OYSTER CREEK NUCLEAR GENERATING STATION, UNIT NO. 1

AMENDMENT TO PROVISIONAL OPERATING LICENSE

Amendment No. 24
License No. DPR-16

SAFETY EVALUATION BY THE OFFICE OF NUCLEAR REACTOR REGULATION

FIGURE 3.10.1

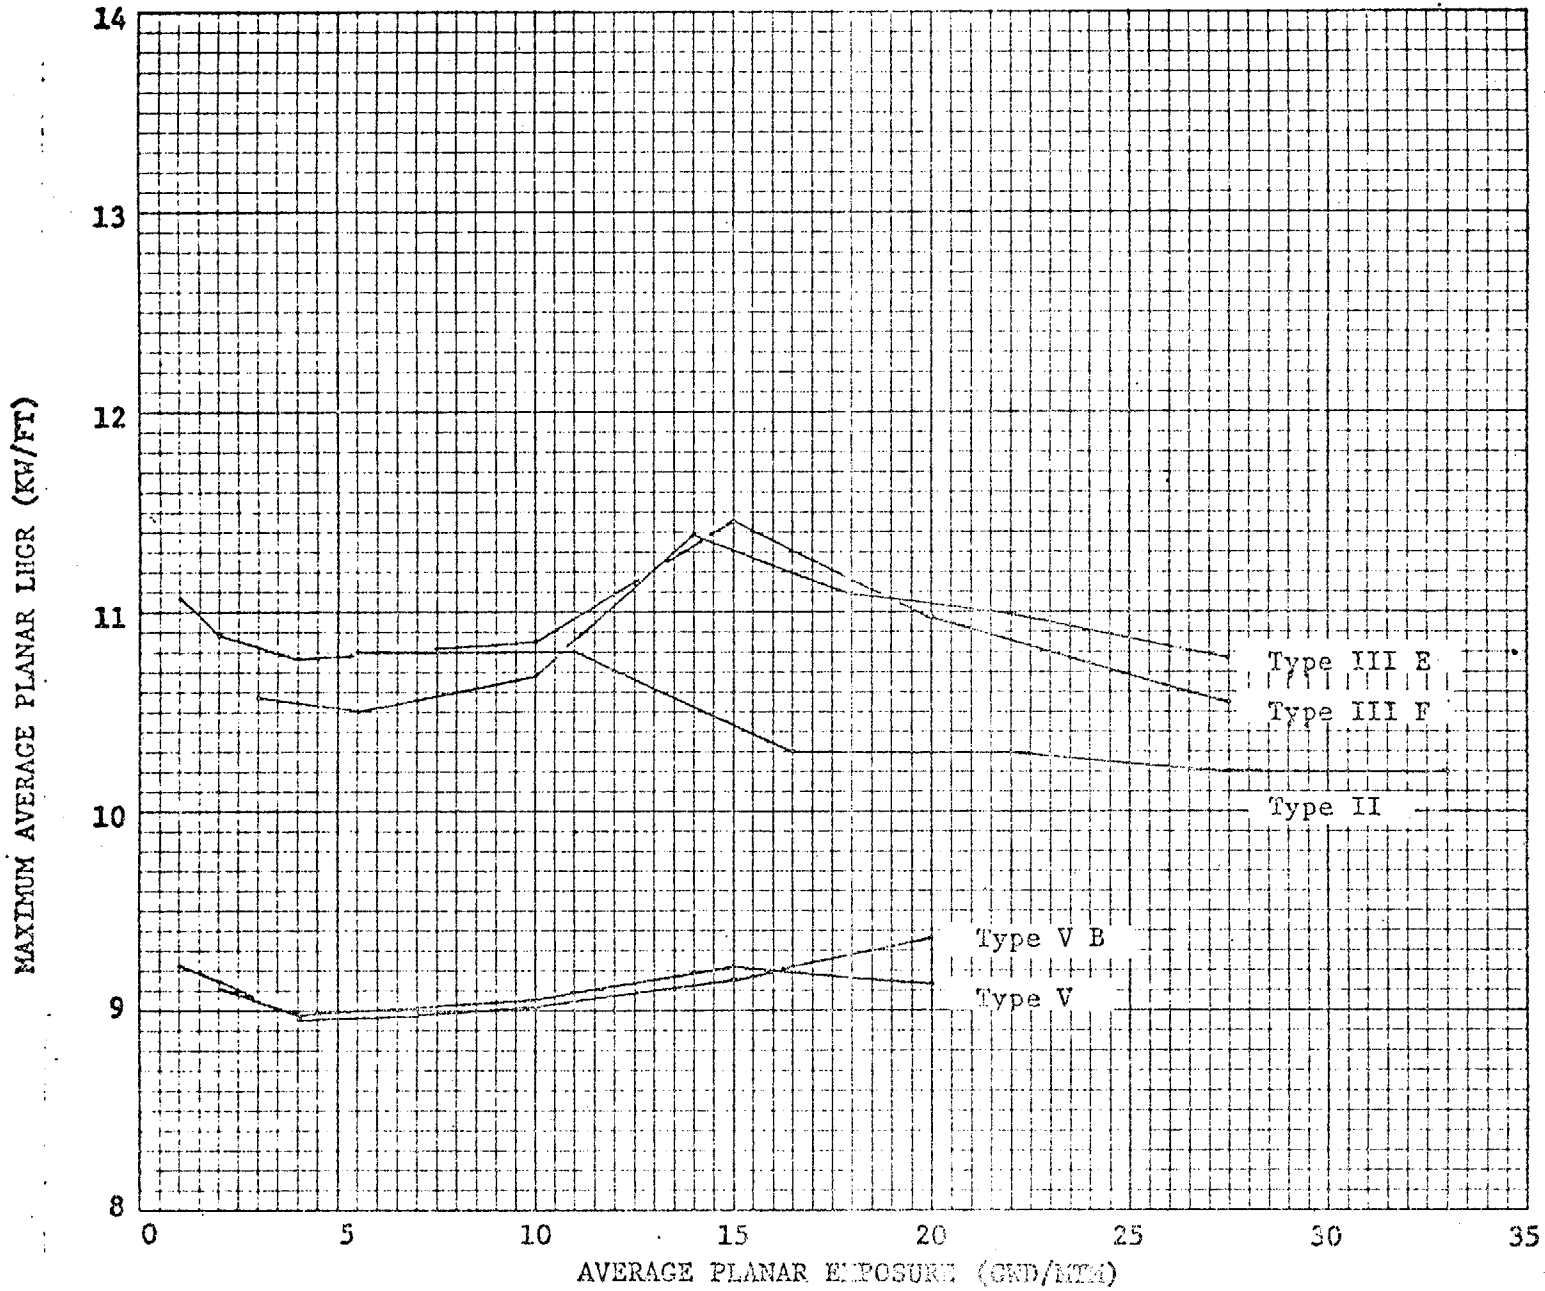
In the application for amendment, JCP&L has extended the Maximum Allowable Average Planar Linear Heat Generation Rate specification for fuel types currently in the core by modifying Figure 3.10.1. This modification extends the calculated Maximum Average Planar Linear Heat Generation Rate (MAPLHGR) from 15 GWD/MTM (thousand megawatt days/metric ton) to 20 GWD/MTM for fuel types V and VB, from 20 GWD/MTM to 27.5 GWD/MTM for fuel type IIIF and from 22 GWD/MTM to 27.5 GWD/MTM for fuel type IIIE. The calculated MAPLHGR for fuel type II was not extended.

The extensions of MAPLHGR shown in Figure 3.10-1 for types IIIE, IIIF, V, and VB fuel are the results of an analysis using an approved ECCS evaluation model in agreement with Appendix K to 10 CFR Part 50. This LOCA analyses, performed by Exxon Nuclear Company (ENC), utilized blowdown

results obtained from General Electric Company which reflect revised single failure considerations. In addition, the MAPLHGR extensions shown in Figure 3.10-1 for types V and VB fuel were analyzed with 100% of the spray cooling coefficient specified in Appendix K to 10 CFR Part 50 for 7 x 7 fuel.

We have reviewed the proposed changes and have concluded that they do use the methods found acceptable by the NRC staff, do not change MAPLHGR limits previously found acceptable and only extend the current calculations to higher fuel exposures and therefore are acceptable.
